ADDENDUM BUSHFIRE HAZARD ASSESSMENT

PP2023-2403

PLANNING PROPOSAL FOR 322 STUARTS POINT ROAD, YARRAHAPINNI

*Bushfire Hazard Assessment – Stuarts Point Road, Yarrahapinni – Rezoning*

Supplementary plan for Illustration 3.1

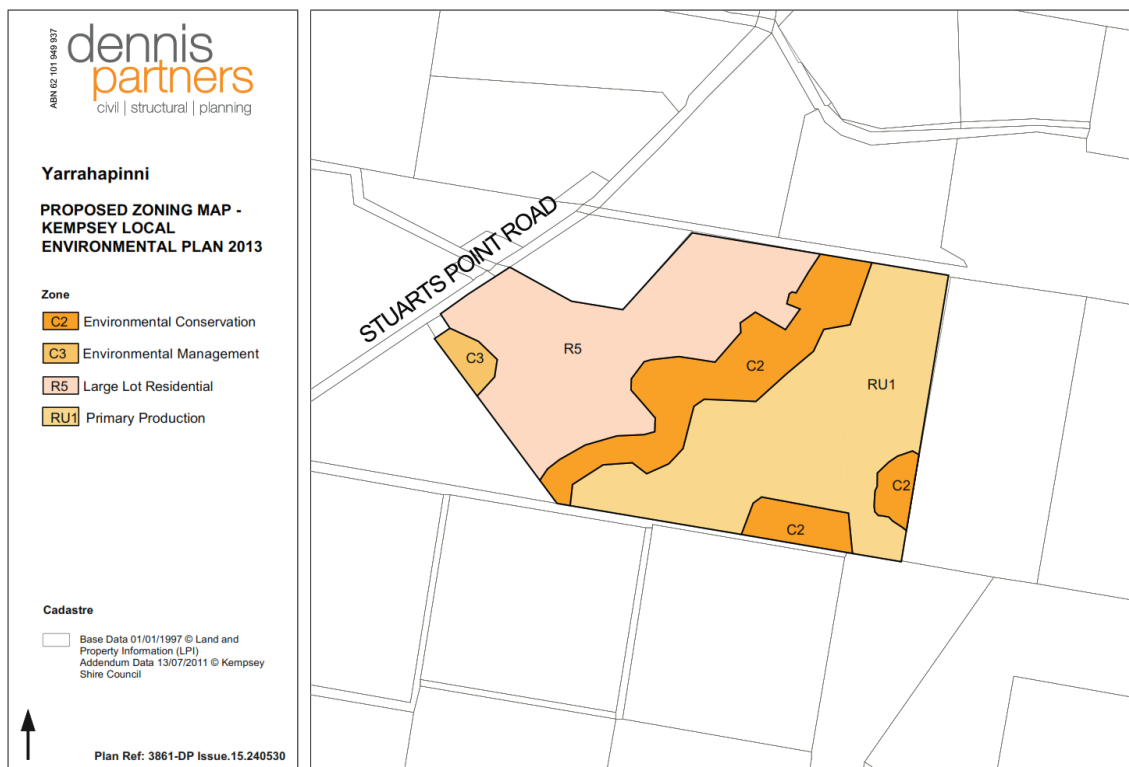
Section 2.2 Proposed Development	Page 6	Reference to 25 lots to be replaced with reference to 17 lots.
Section 4	Page 12	Reference to 25 lots to be replaced with reference to 17 lots.
Section 5.1 Asset Protection Zones	Page 18	Supplement with the map below for 17 lots.
Section 5.2 Access	Page 19 4 <sup>th</sup> paragraph	Delete "to 25".
Table 5.3	Page 20	Access egress roads reduced in length and no longer cross the creek. Lots 17 – 25 now only a single consolidated lot east of the creek referred to as Lot 17.
Table 5.3	Page 22	Remove reference to Lot 25. Retain comments on Lot 7.
Section 5.2.1.2 Drainage Corridor Vegetation	Page 23	1st paragraph – remove last sentence there are no longer any allotments proposed east of the drainage corridor. 5 <sup>th</sup> paragraph – replace reference "Lot 25" to "Lot 17".
Section 2.1.3.	Page 24	Turning circle adjacent forest vegetation no longer in the proposal. 12m radius turning circle now west of the creek.

Section 6.1	Page 27	3 <sup>rd</sup> dot point, amend Lot 25 to read Lot 17.
Appendix A		Supplement with the revised zone map below with not R5 east of the creek.
Appendix B		Supplement with the map below revised plan of subdivision map and subdivision with aerial imagery below, with no 1 ha allotments east of the creek.
